HISTORIC AND DESIGN REVIEW COMMISSION

HDRC CASE NO: 2020-435
COMMON NAME: 1111 & 1115 N Palmetto
LEGAL DESCRIPTION: NCB 1302 BLK 3 LOT E 144.84 FT OF 10
ZONING: R-5, H
CITY COUNCIL DIST.: 2
DISTRICT: Dignowity Hill Historic District
APPLICANT: James Benfield/Benfield Real Estate
OWNER: James Benfield/Benfield Real Estate
TYPE OF WORK: Construction of two, 2-story residential structures
APPLICATION RECEIVED: September 28, 2020
60-DAY REVIEW: Not applicable due to City Council Emergency Orders
CASE MANAGER: Edward Hall

REQUEST:

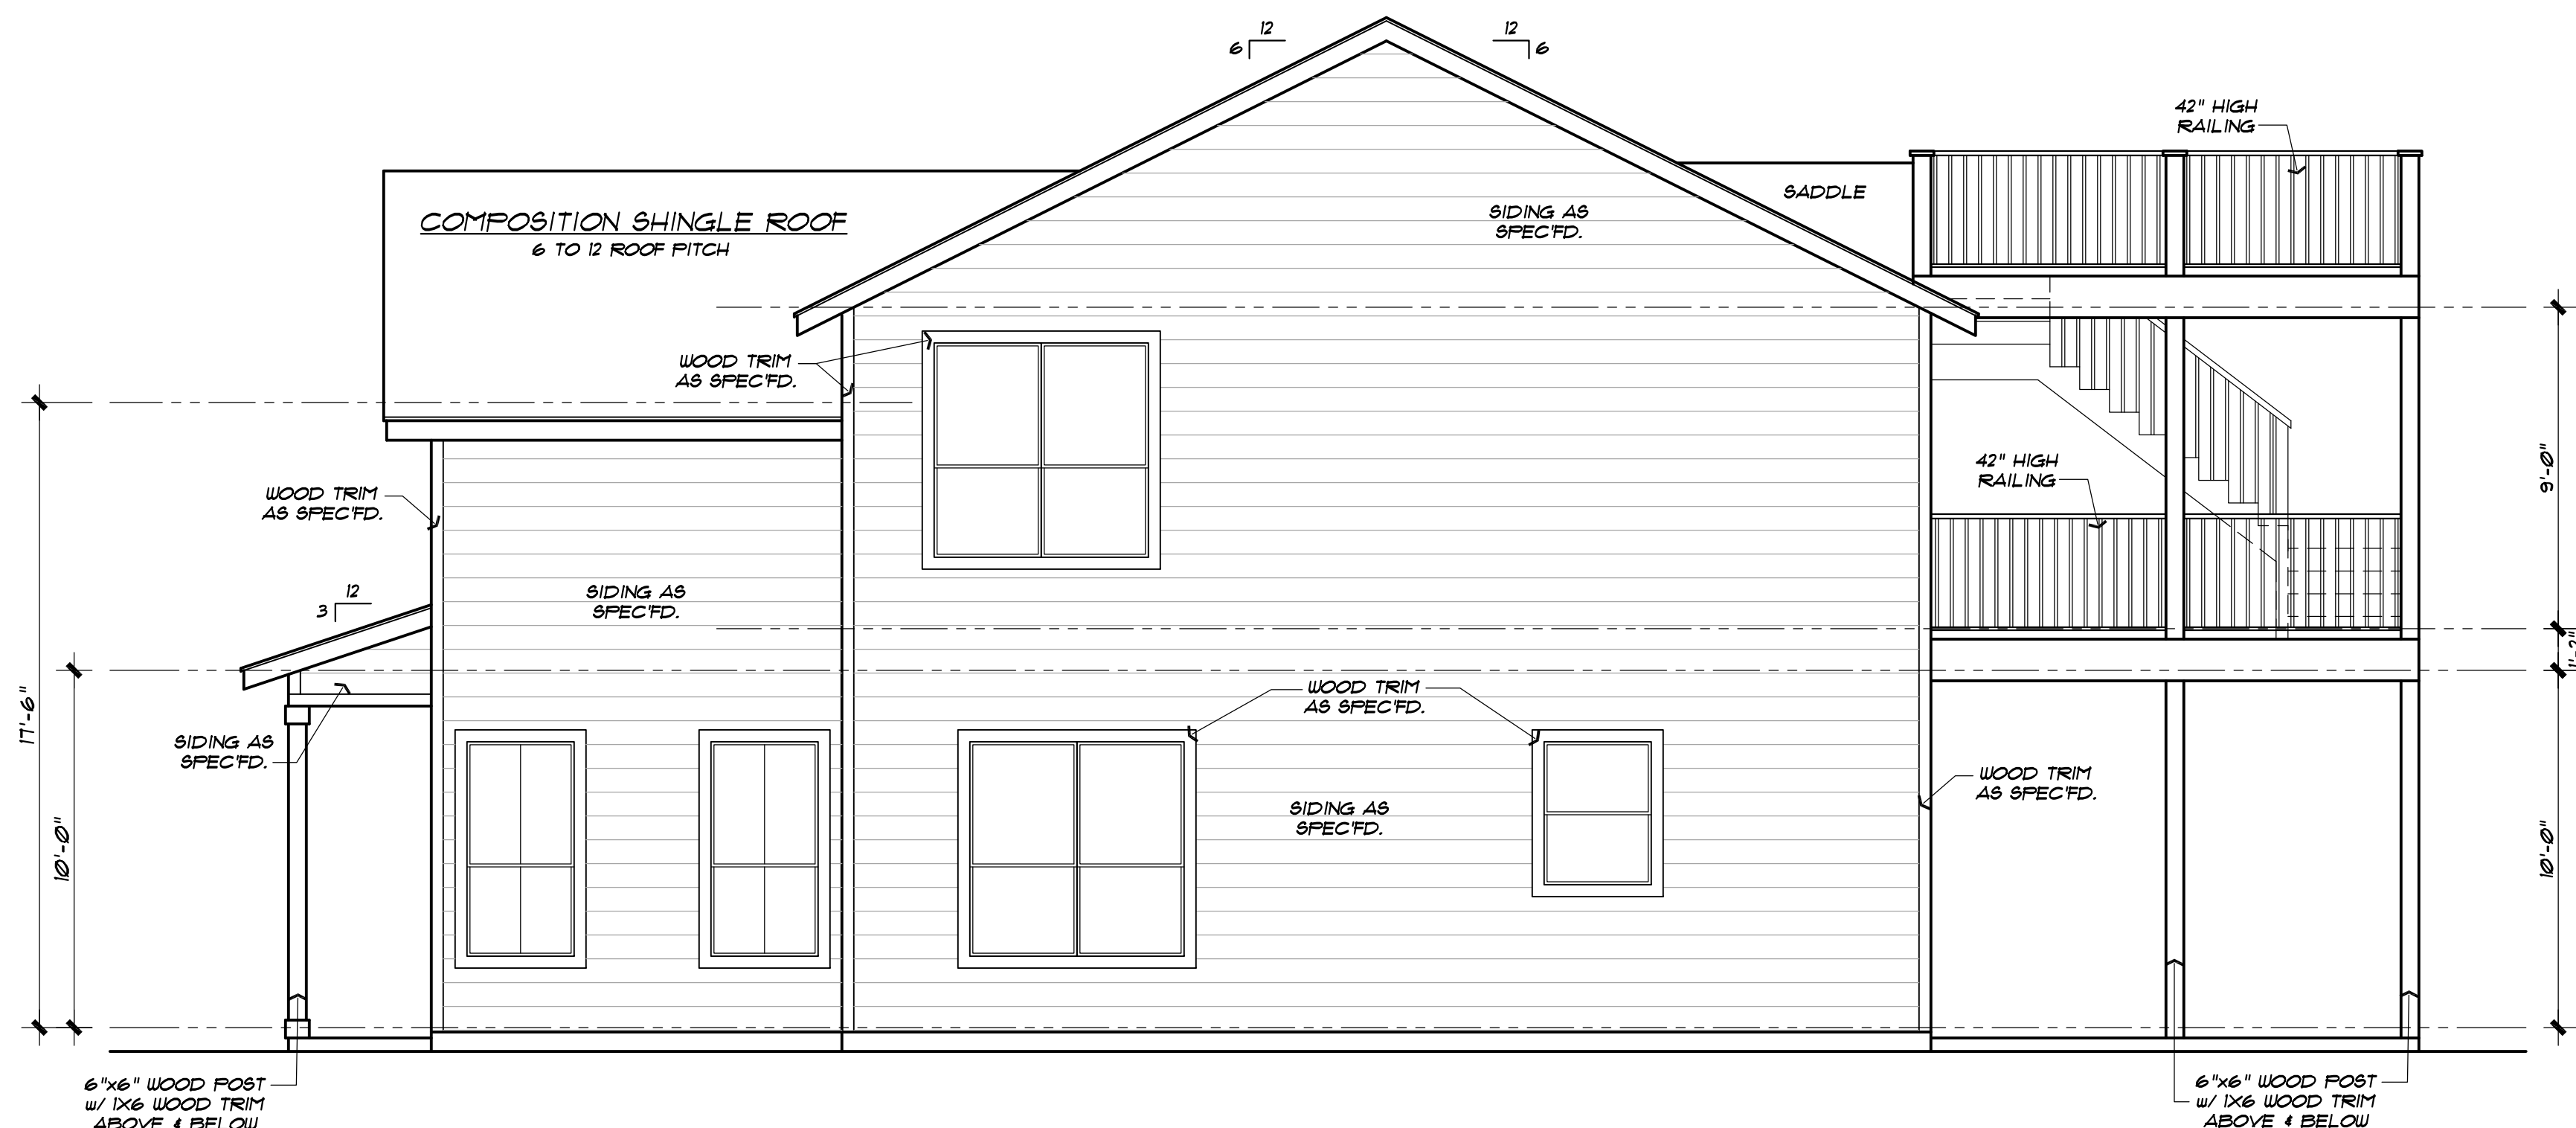
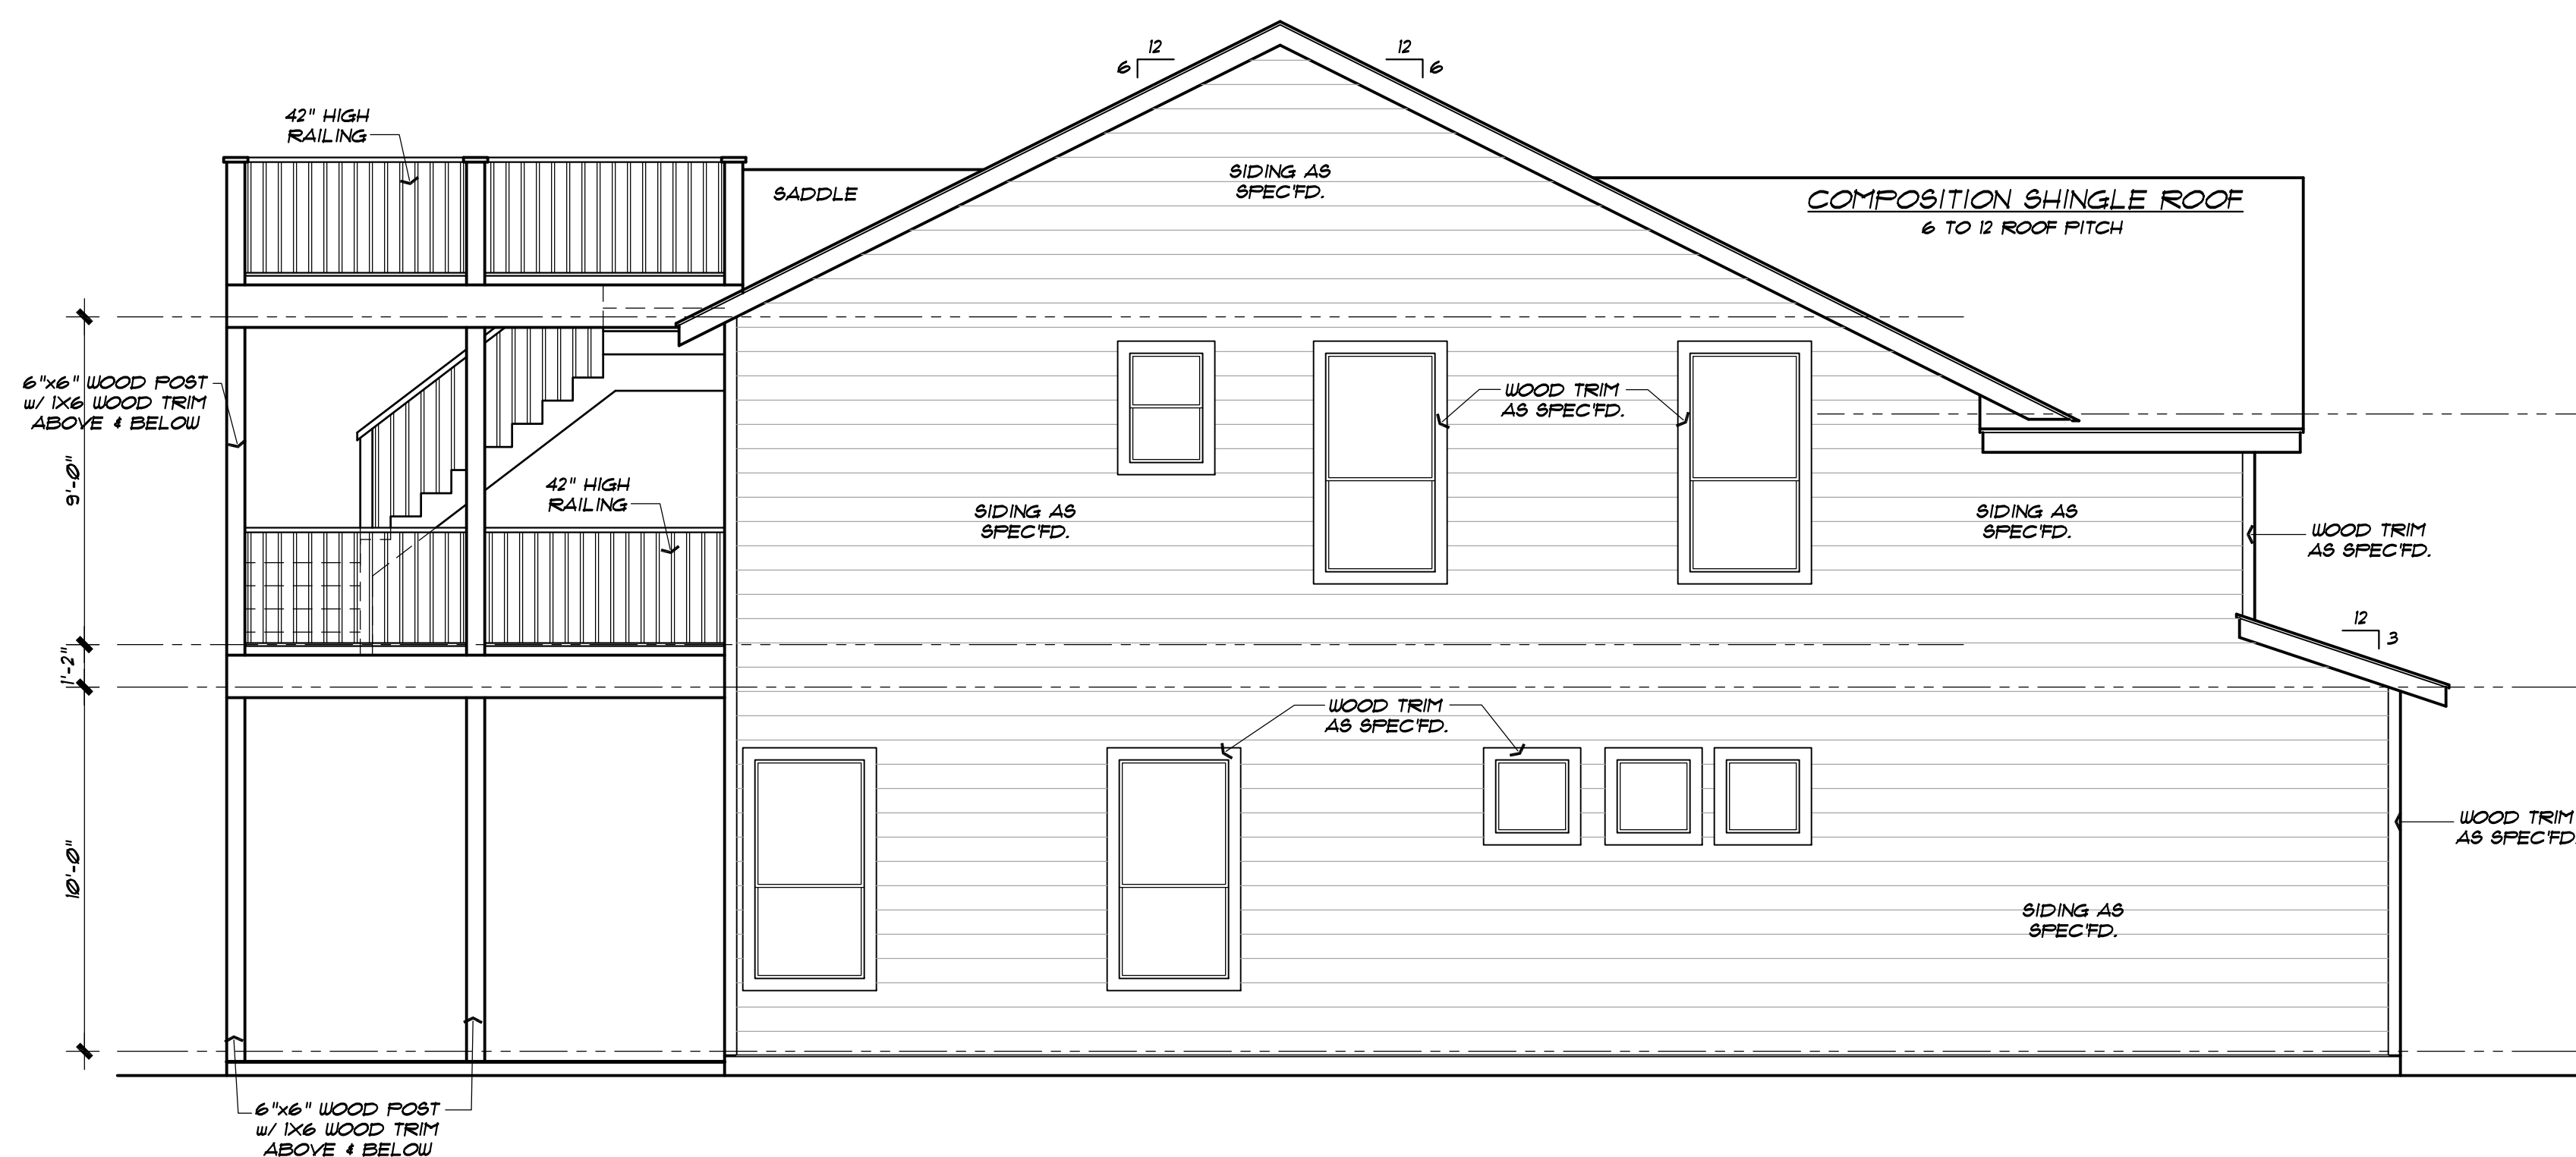
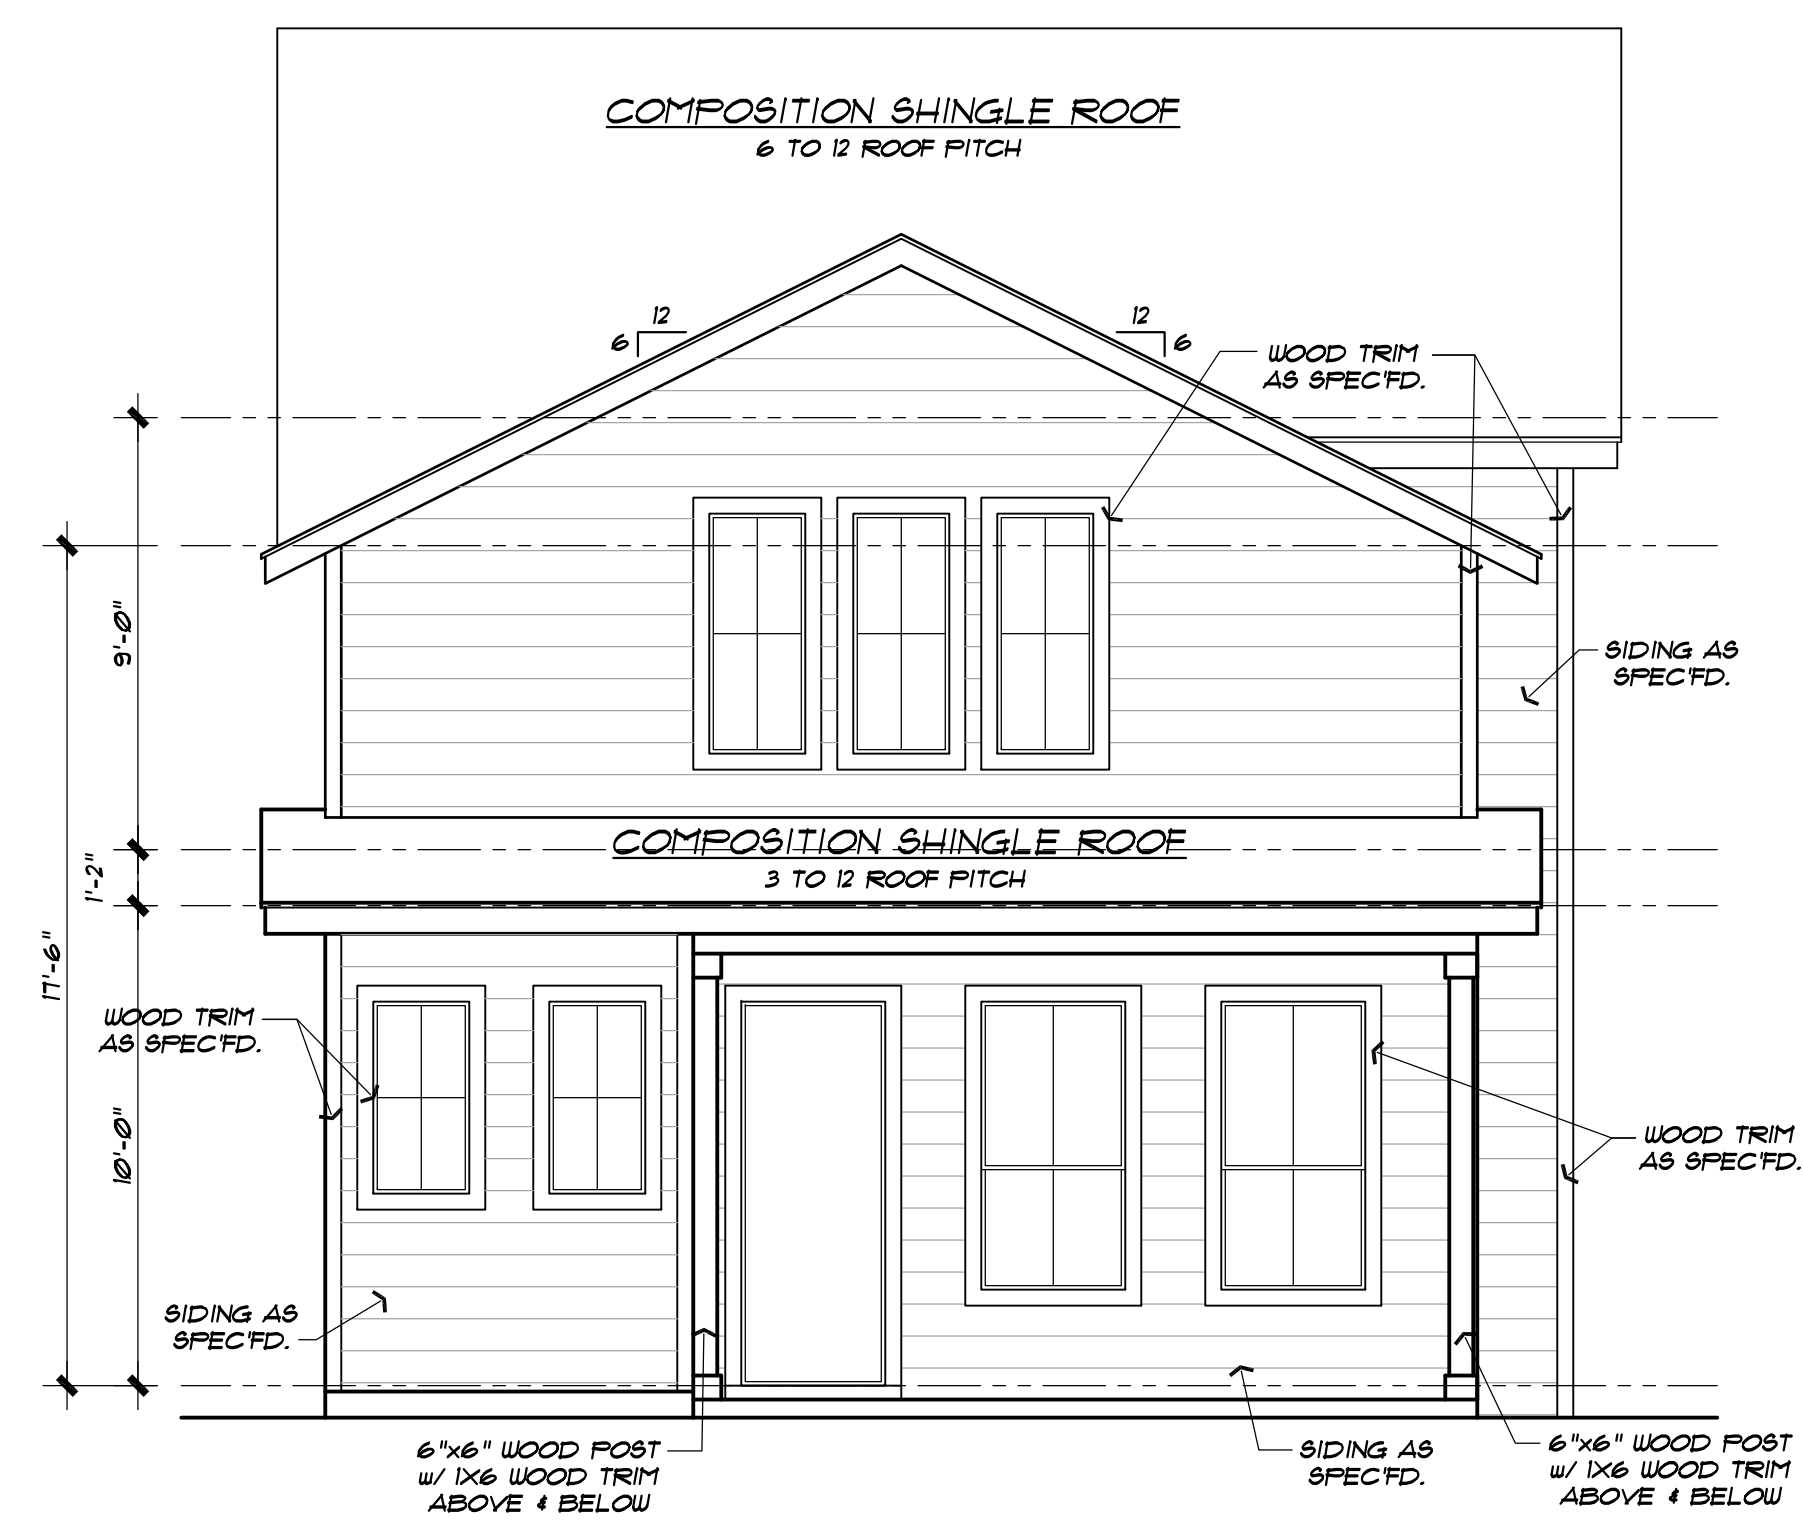
- 2b. **SCALE & MASS** – Per the Guidelines for New Construction 2.A.i., a height and massing similar to historic structures in the vicinity of the proposed new construction should be used. In residential districts, the height and scale of new construction should not exceed that of the majority of historic buildings by more than one-story. As noted in finding b, this block on N Palmetto features all one story structures. The applicant has proposed an overall height of approximately twenty-seven (27) feet. Because of the change in scale, staff finds that it would be more appropriate to incorporate several design strategies to mitigate the visual impact of the additional height including utilizing a half story or an additional increase in front yard setback.

- 2d. **FOUNDATION & FLOOR HEIGHTS** – Per the Guidelines for New Construction 2.A.iii., applicants should align foundation and floor-to-floor heights within one foot of floor-to-floor heights on adjacent historic structures. The applicant has not specified the exact foundation height. The applicant is responsible for complying with the Guidelines regarding foundation heights.

- 2e. **ROOF FORMS** – The applicant has proposed roof forms that include front and side facing gabled roofs. Staff finds the proposed roof forms to be appropriate and consistent with the Guidelines.

- 2f. **WINDOW & DOOR OPENINGS** – Per the Guidelines for New Construction 2.C.i., window and door openings with similar proportions of wall to window space as typical with nearby historic facades should be incorporated into new construction. Staff finds that all ganged and grouped windows should be separated by a mullion of at least six (6) inches in width. Additionally, staff finds that windows should be added to both the north and south facades near the front of both structures and that non-traditionally sized window openings should be eliminated, such as fixed square windows.

- 2g. **PORCH MASSING** – The applicant has proposed porch massing that is integral to the massing of both structures. Generally, staff finds the proposed porch massing to be appropriate; however, staff finds that the proposed porch depth should be increased to at least five (5) feet.

- 2l. **ARCHITECTURAL DETAILS** – As noted in finding 2f, staff finds that all ganged and grouped windows should be separated by a mullion of at least six (6) inches in width. Additionally, staff finds that windows should be added to both the north and south facades near the front of both structures and that non-traditionally sized window openings should be eliminated, such as fixed square windows. Additionally, staff finds that porches should be increased in depth to at least five (5) feet, as noted in finding 2g.

- i. That the applicant incorporate several design strategies to mitigate the visual impact of the additional height including utilizing a half story or an additional increase in front yard setback. as noted in findings 1b and 2b.

- ii. That foundation heights that are consistent with the Guidelines be utilized as noted in findings 1d and 2d.
- iii. That all ganged and grouped windows be separated by a mullion of at least six (6) inches in width. Additionally, staff recommends that windows should be added to both the north and south facades near the front of both structures and that non-traditionally sized window openings should be eliminated, such as fixed square windows, as noted in findings 1f and 2f.

- iv. That the applicant increase the porch depth to at least five (5) feet as noted in findings 1g and 2g.
- v. That the applicant install windows that meet staff's standards specifications as noted in findings 1j and 2j.

Arch Single-Hung Window Details

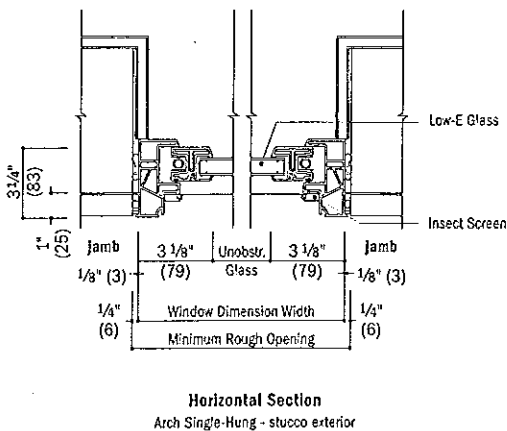
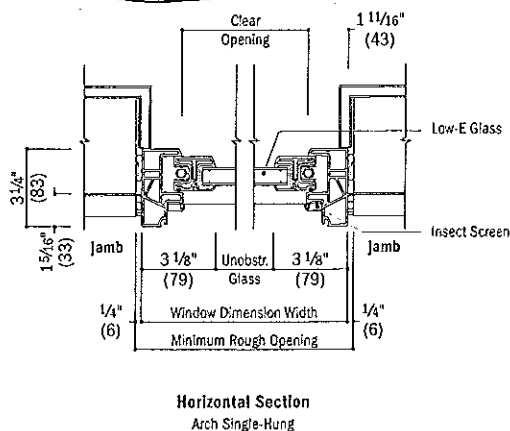
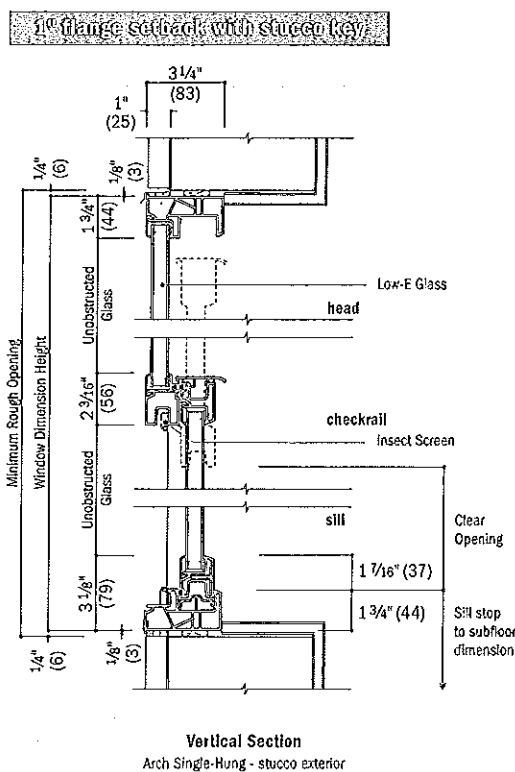
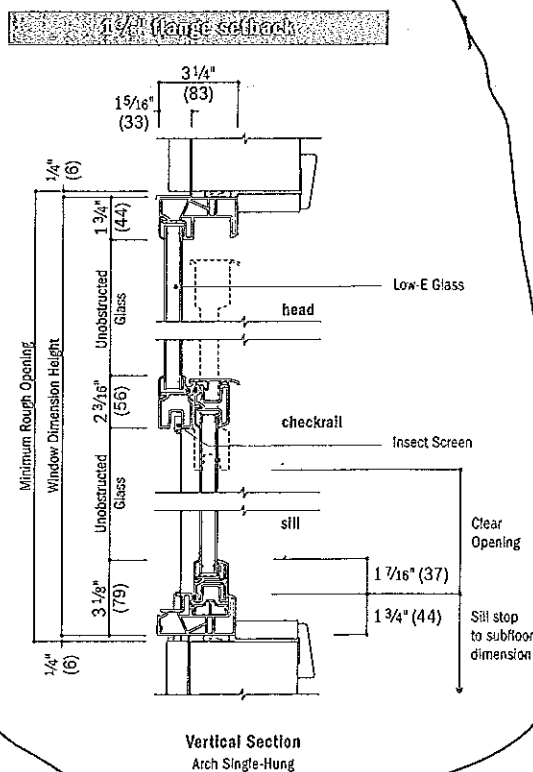
- 1j. WINDOW MATERIALS – The applicant has proposed to install aluminum windows. The proposed windows are not consistent with staff’s standards for windows in new construction in regards to meeting rail and top and bottom rail dimensions.

- 2j. **WINDOW MATERIALS** – The applicant has proposed to install aluminum windows. The proposed windows are not consistent with staff's standards for windows in new construction in regards to meeting rail and top and bottom rail dimensions.
